# Construction Traffic Management Plan – Pitt Street South Site – Demolition Works Amendment 1

Project: Sydney Metro City & Southwest – TSE Works

Document No: SMCSWTSE-JCG-SPS-TM-PLN-002288

**RE: Endorsement of Construction Traffic Management Plan – Pitt Street South Site - Demolition Works Amendment 1: Sydney Metro City & Southwest – TSE Works**

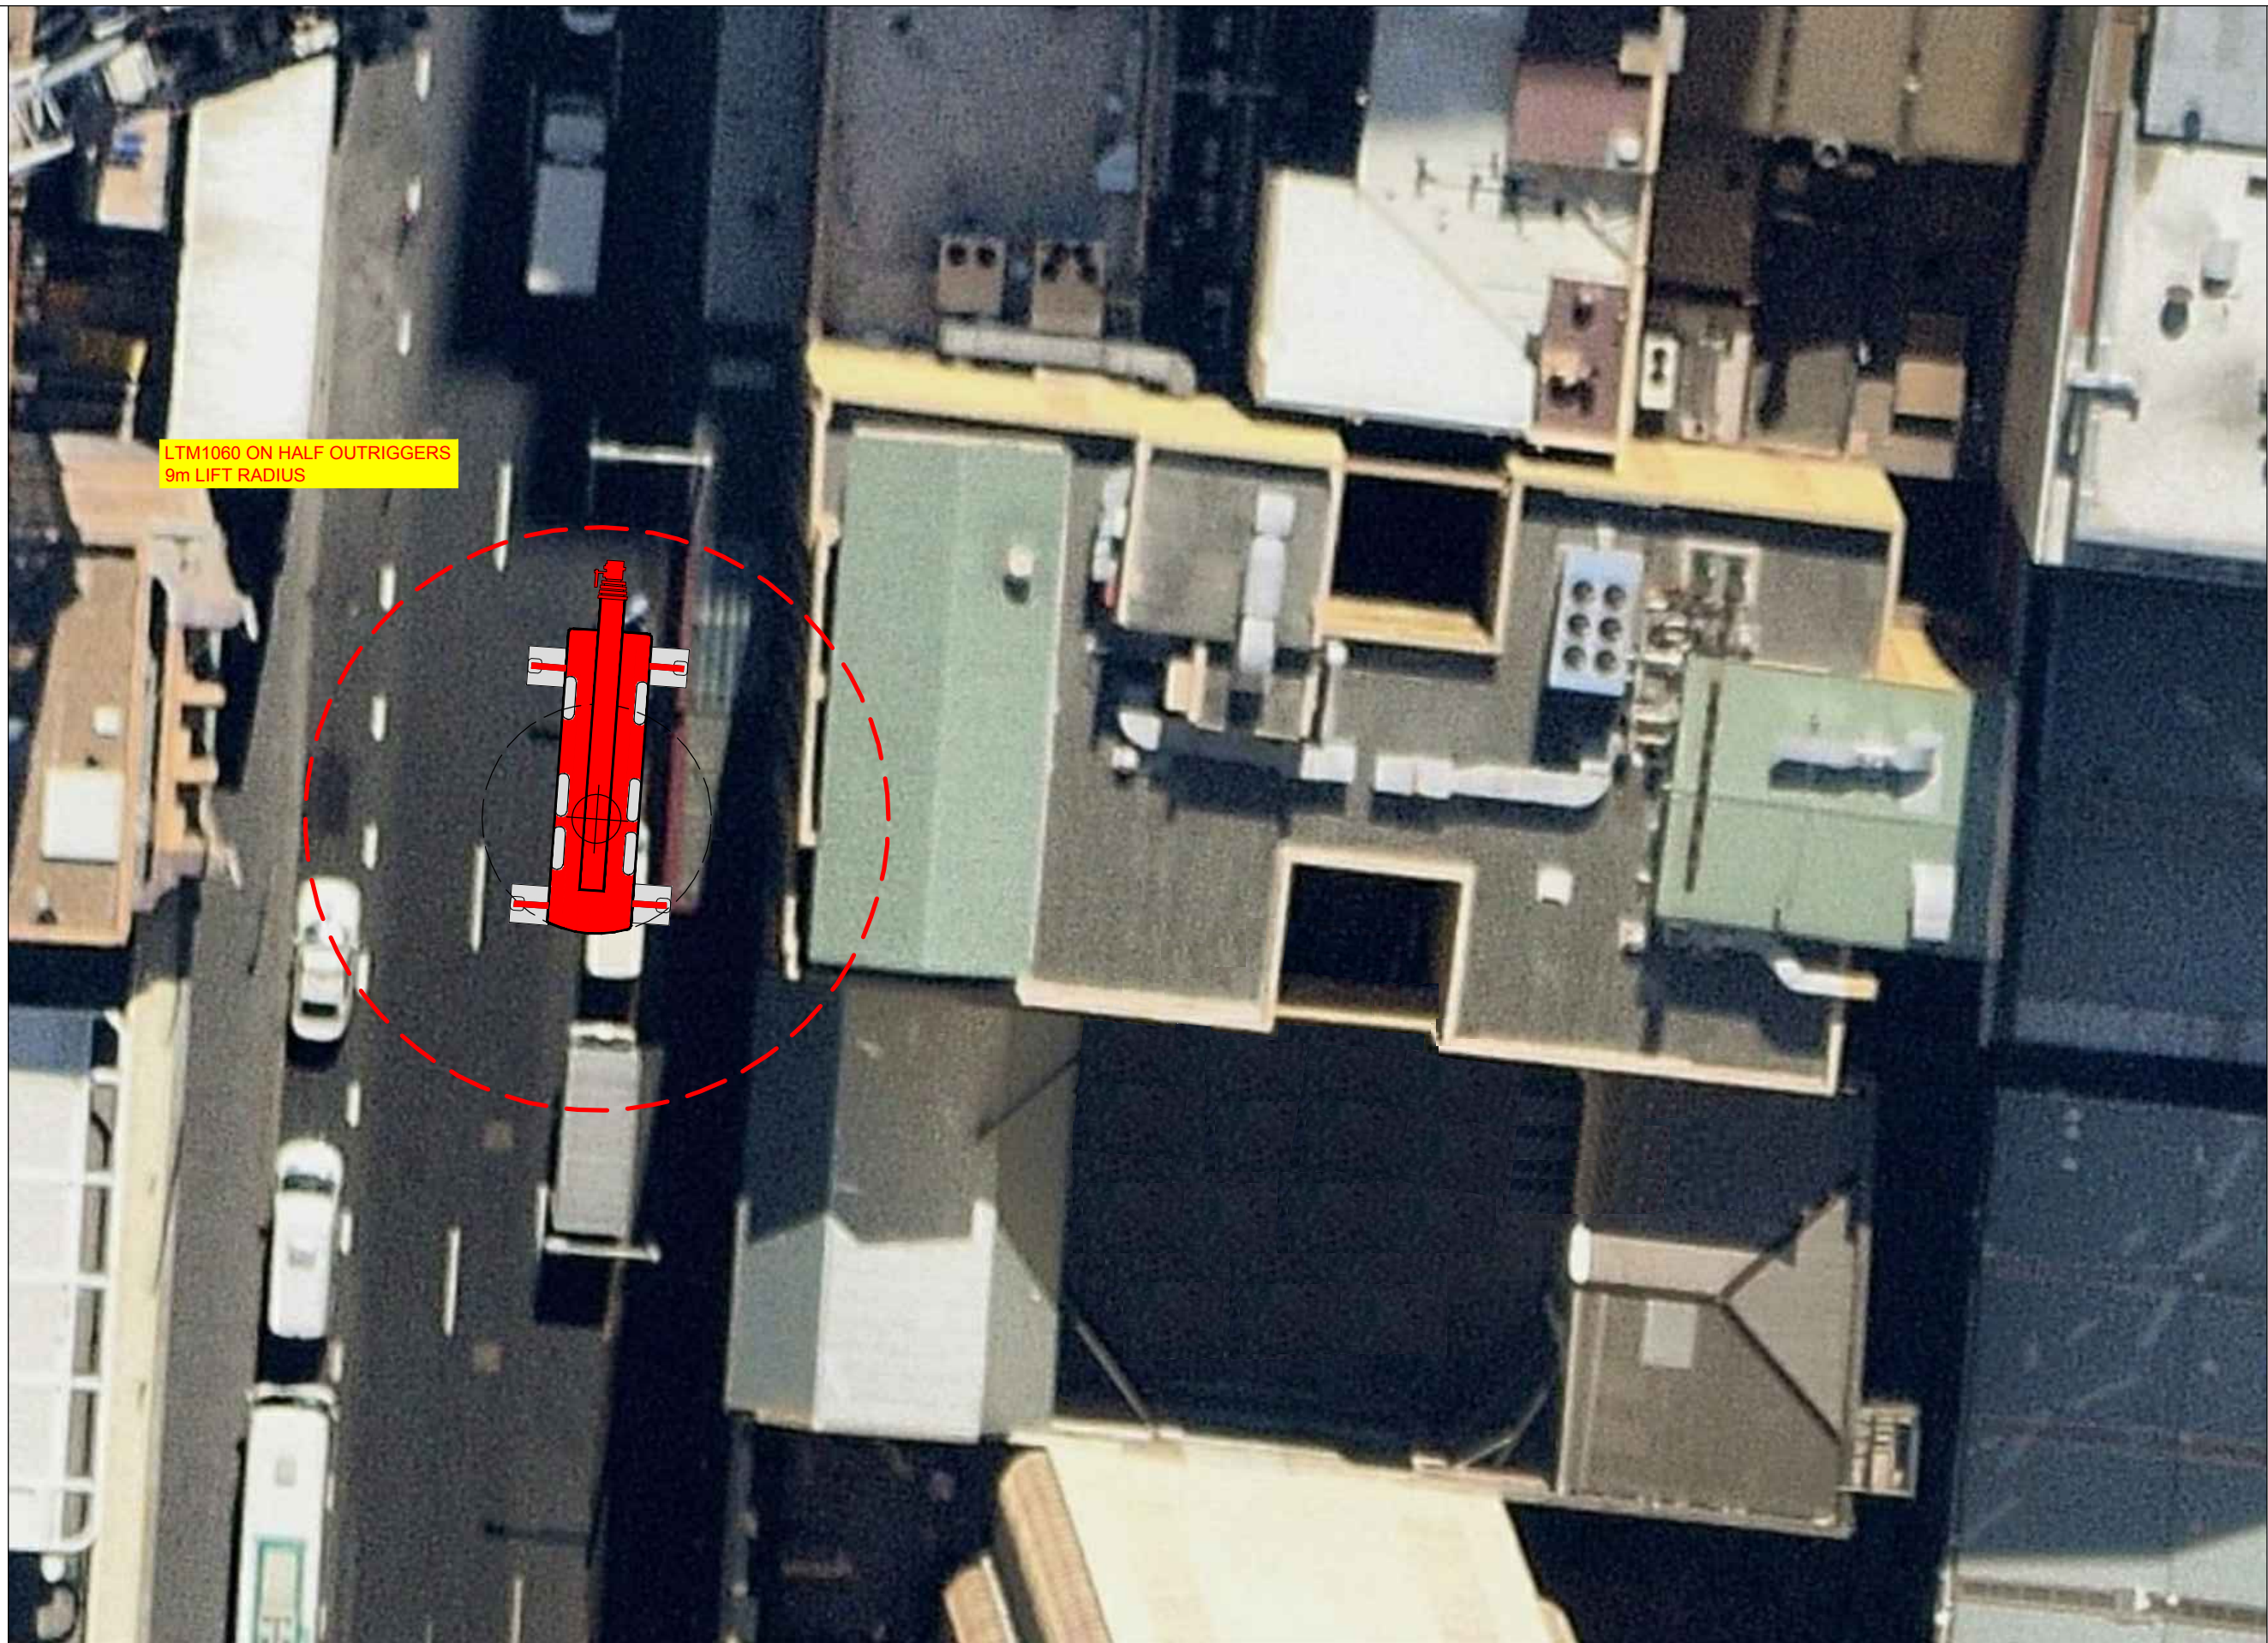
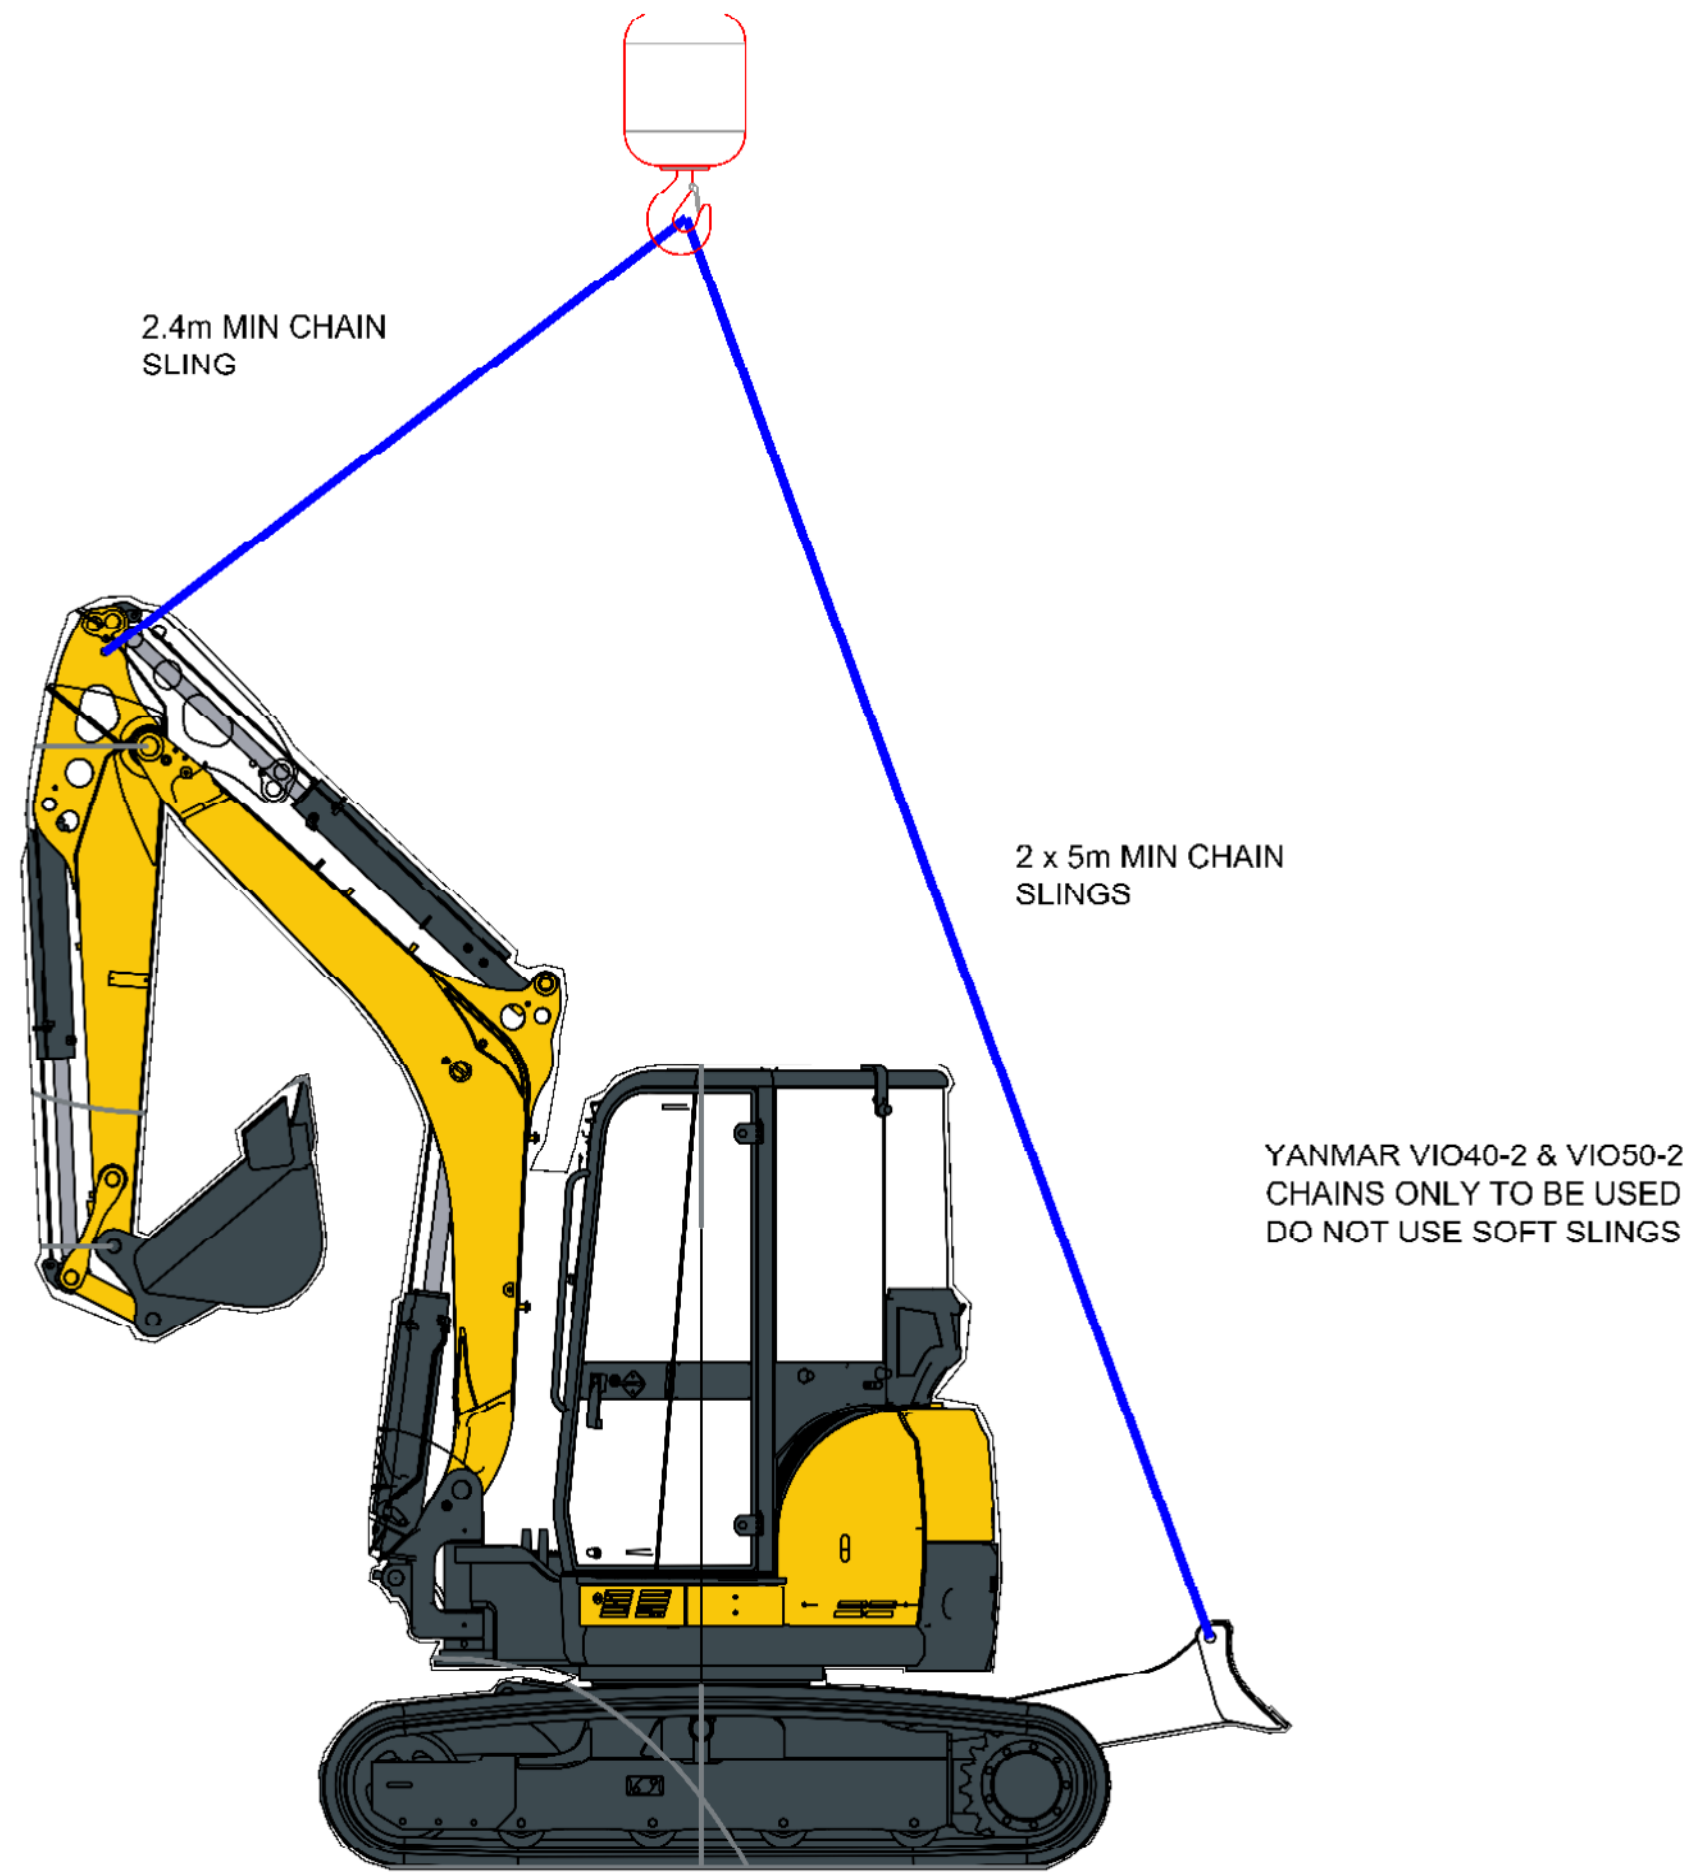
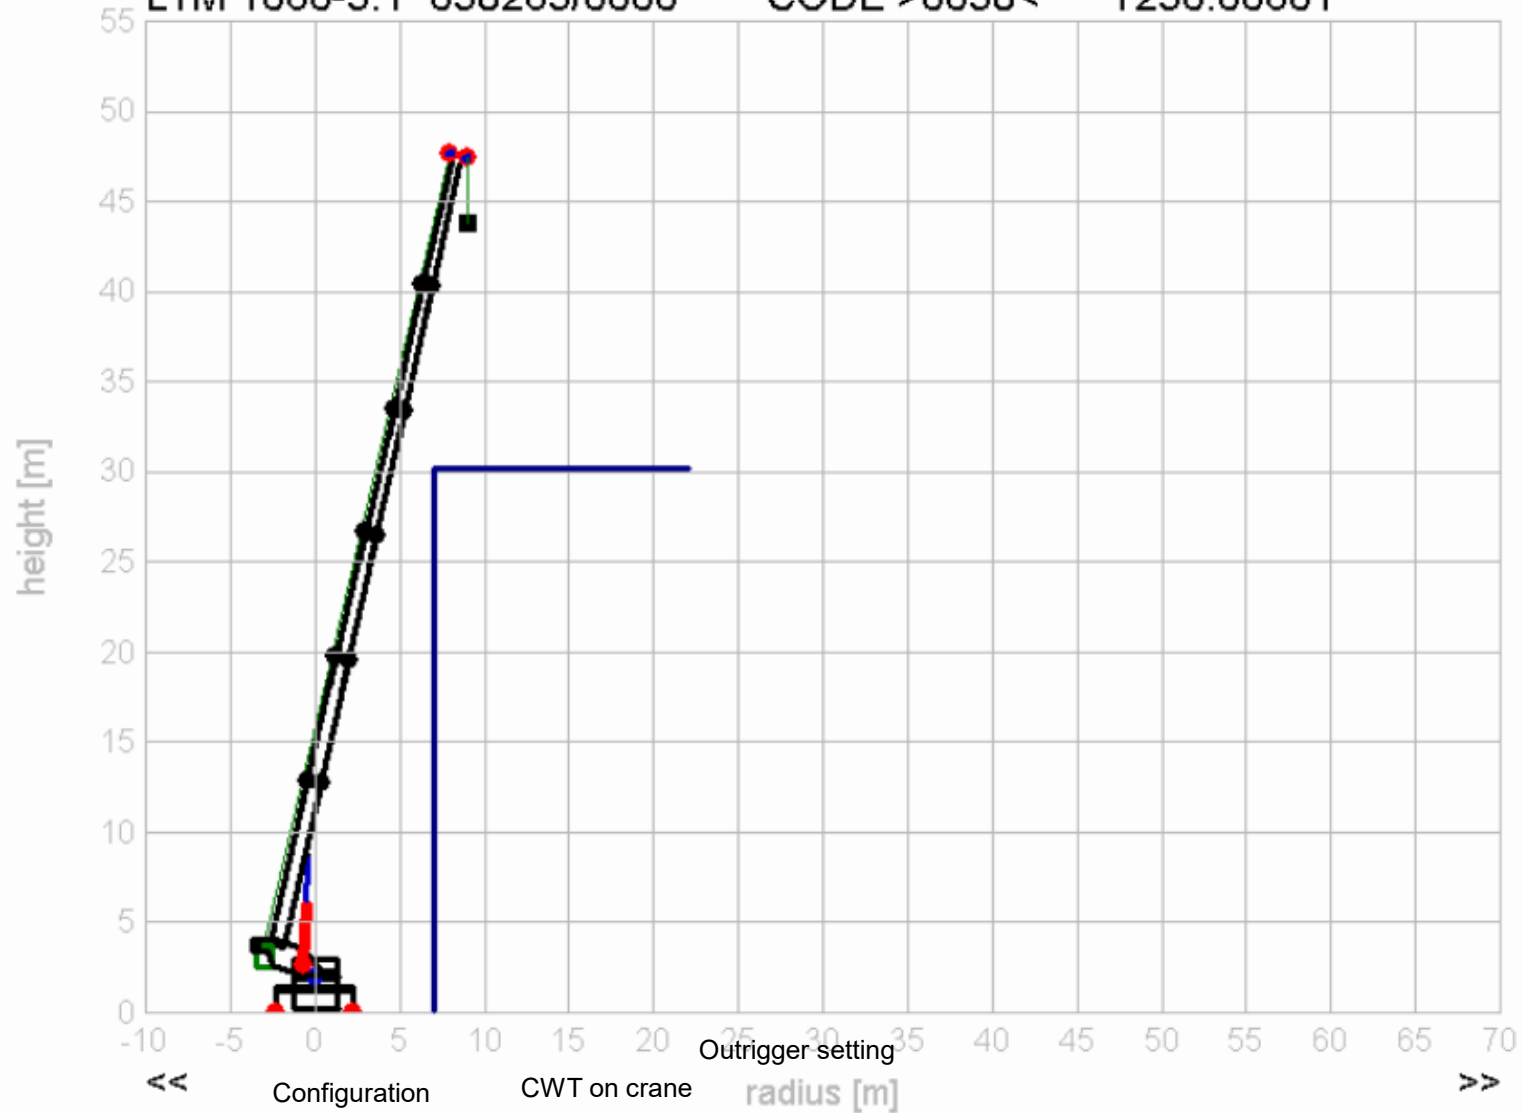
8	TSE	JHCPBG	E		RMS	CM	03-May-2018	App 1	Although there is a drawing number indicated on the table, no drawing number is provided on the drawing.	There is no drawing number indicated on the table - this drawing is part of the Lift Study	Open	The table shown on page 15 of the pdf (Appendix 1 Parking restrictions) indicates a drawing number. The drawing on page 16 of the pdf does not have a drawing number on it. The information at the bottom of the drawing in the title block is generally missing.	Drawing number added
9	TSE	JHCPBG	E		RMS	CM	03-May-2018	App 1	Should clarify whether the 'existing parking restrictions' refers to the restrictions before Pitt Street South Demolition CTMP, or under the Pitt Street South Demolition CTMP, but before Amendment 1.	There were no changes required for the Pitt Street South demolition CTMP. The parking changes only came about when we had the on site meeting with Council this year as suggested by Council	Closed		Noted
